MARYLAND STATE DEPARTMENT OF HEALTH
HOWARD COUNTY

A SEWAGE DISPOSAL SYSTEM LOCATED AT

SUBDIVISION ROAD 3330 Daisy Rd. LOT 3

LOCATION SURVEY

PERMIT CARD Jan S.T./D.W.

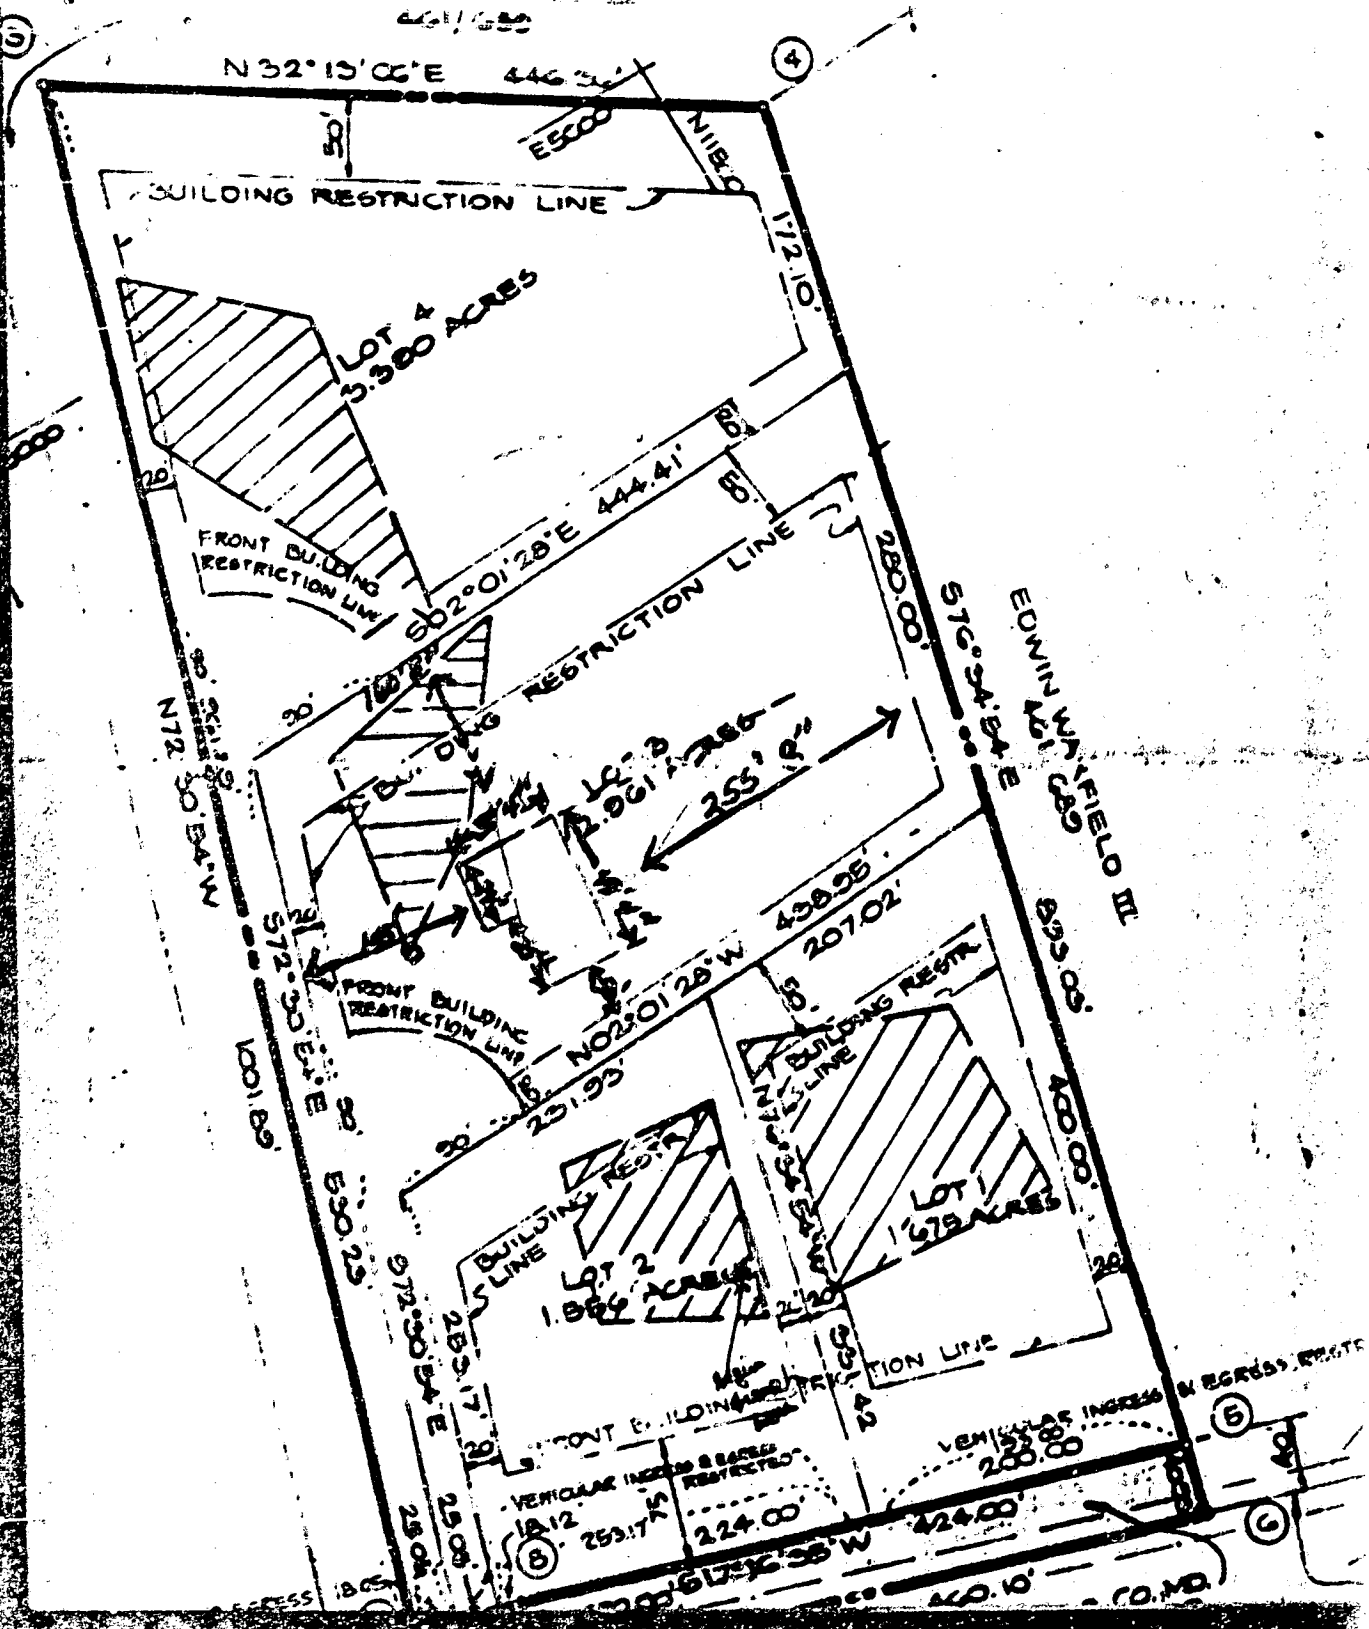
REMARKS (1/2/78 discussed over phone)

Told them to go ahead and put in gravel, but to install a 1500 gallon Septic Tank 2/17/78.

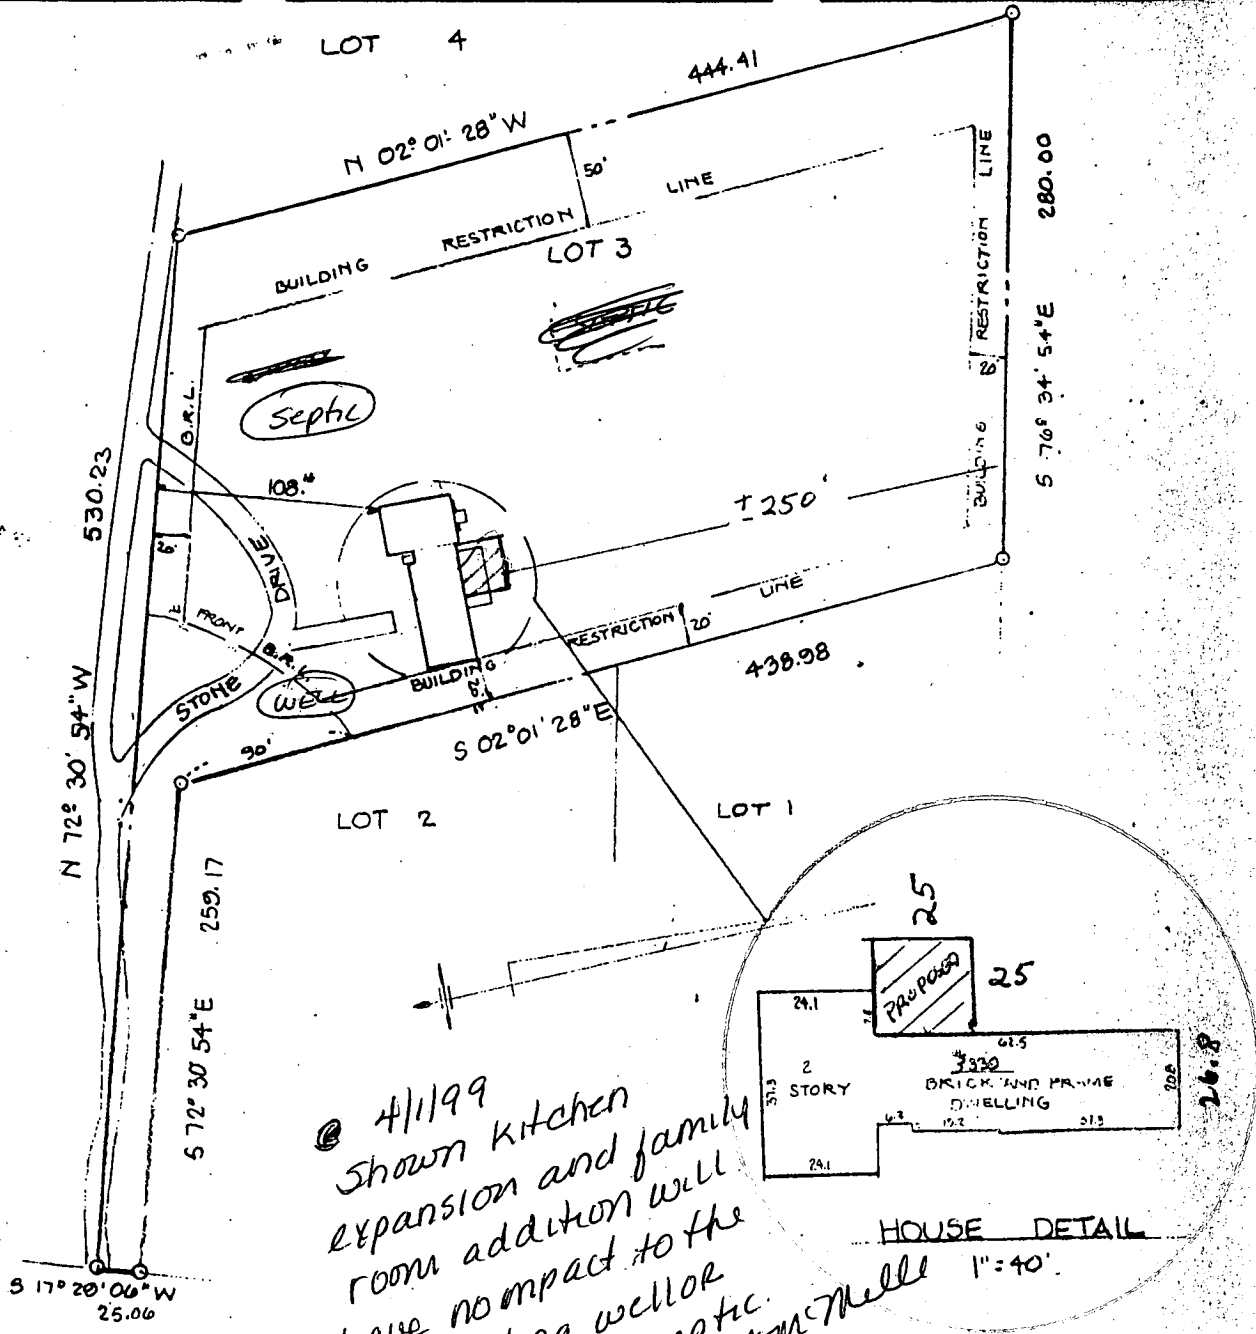
4/1/99
 Shown kitchen
 expansion and family
 room addition will
 have no impact to the
 existing well or
 septic.
 A. McMillen
